V2_Drainage Report - Final_comments.pdf Markup Summary

**ELK VIEW ESTATES
CONSTRUCTION DRAWINGS**

EXISTING CONDITIONS
DRAINAGE MAP

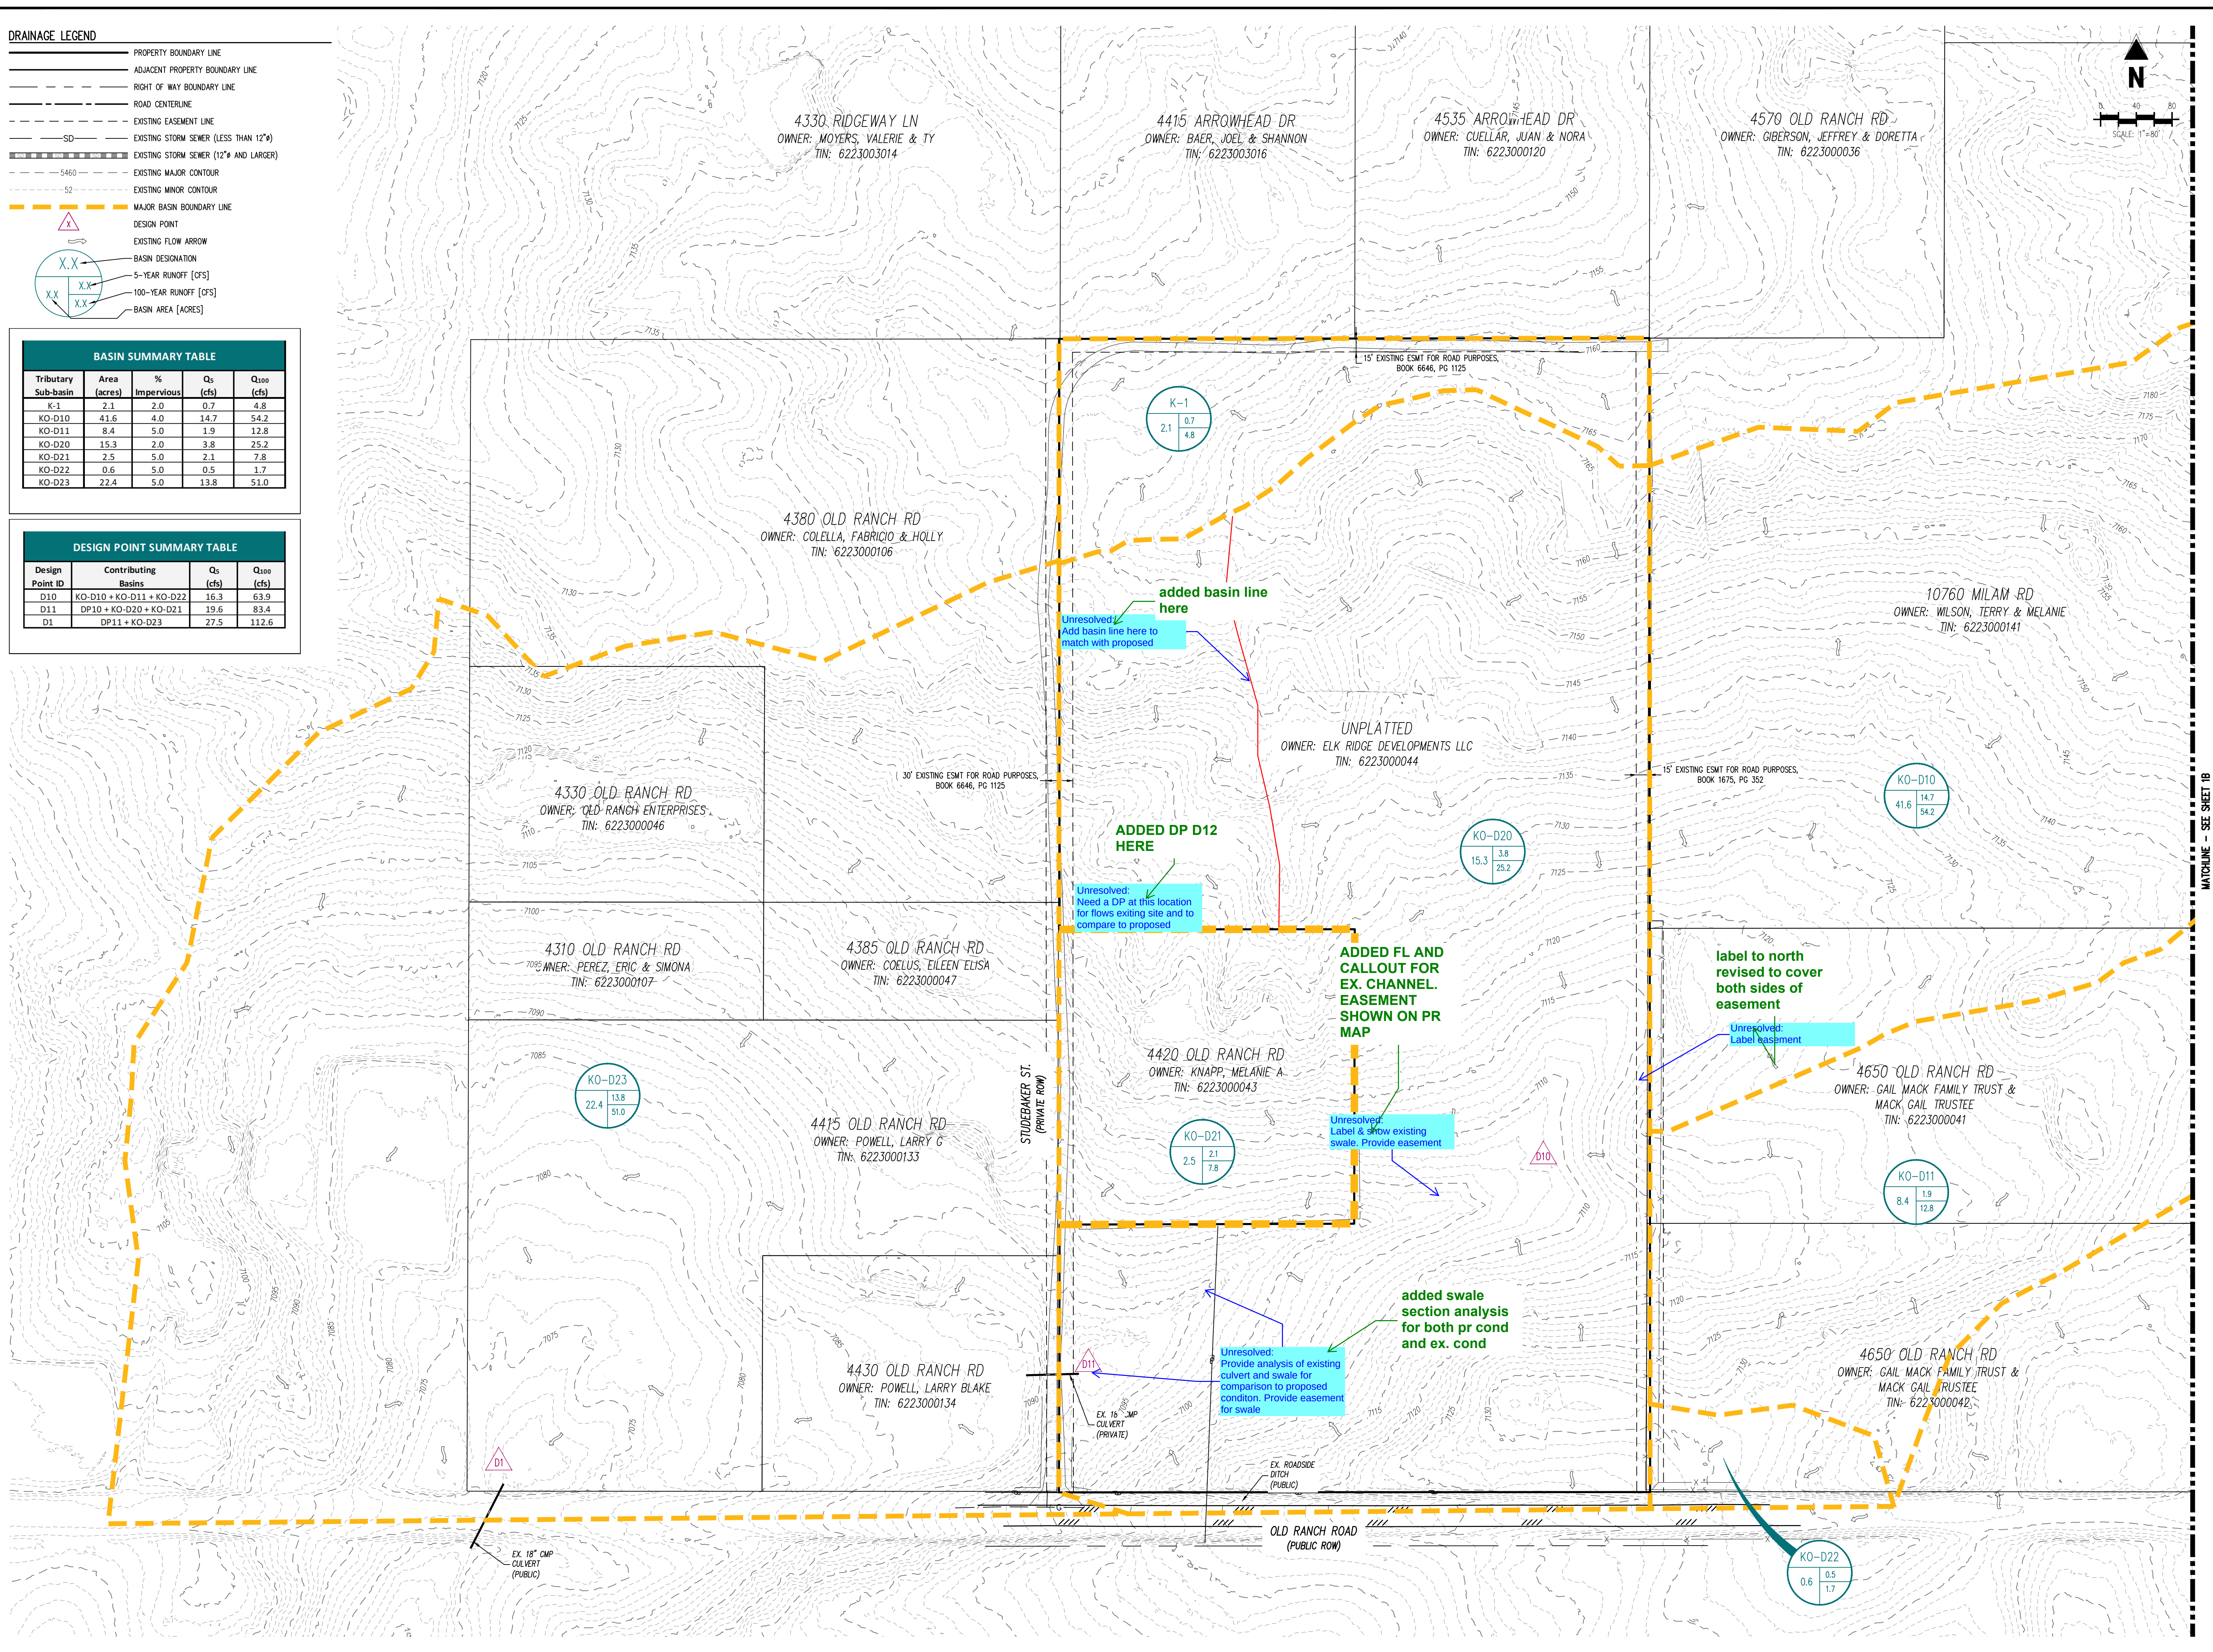
Unresolved:
Label & show existing swale. Provide easement

Unresolved:
Provide analysis of existing culvert and swale for comparison to proposed condition. Provide easement for swale

Unresolved:
Add basin line here to match with proposed

Unresolved:
Label easement

PROPOSED CONDITIONS
DRAINAGE MAP

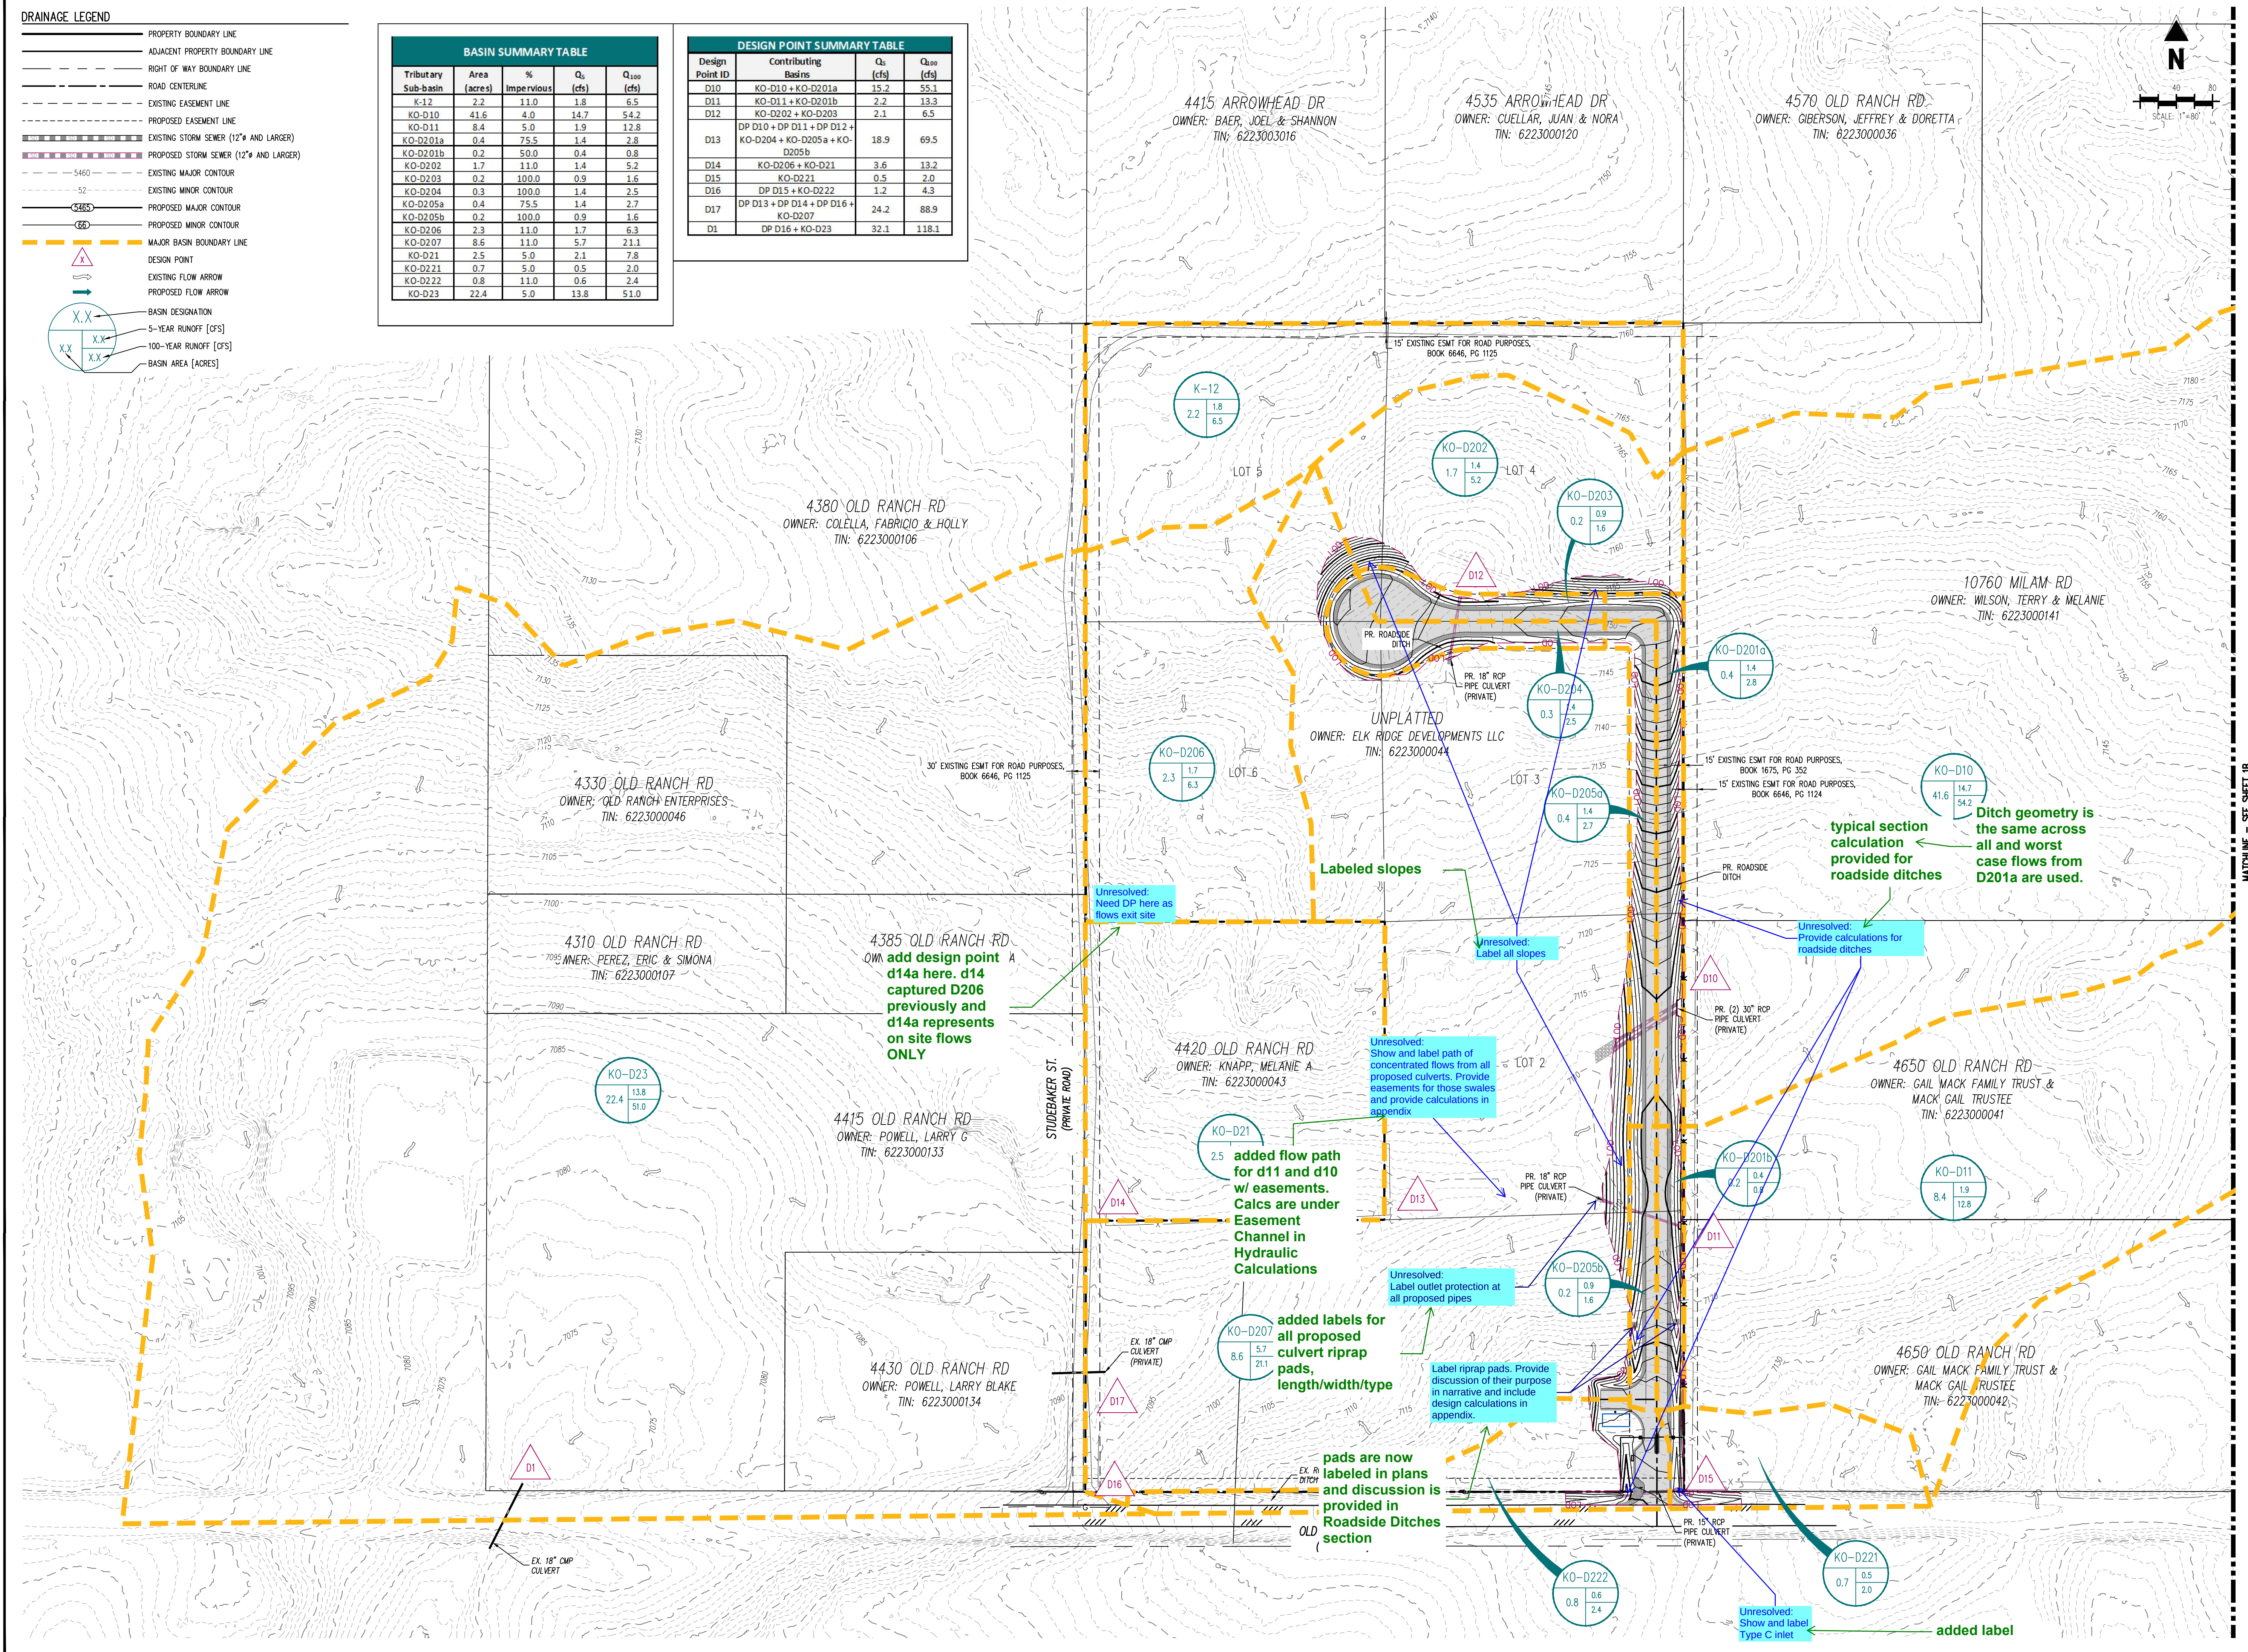
Unresolved:
Label all slopes

Unresolved:
Provide calculations for roadside ditches

Unresolved:
Label outlet protection at all proposed pipes

Unresolved:
Show and label path of concentrated flows from all proposed culverts. Provide easements for those swales and provide calculations in appendix

Unresolved:
Show and label Type C inlet

Label riprap pads. Provide discussion of their purpose in narrative and include design calculations in appendix.

For all RPAs, provide length and width dimensions. It needs to be clear what the exact min dimensions are for maintenance purposes. RPAs should be 80% vegetated.
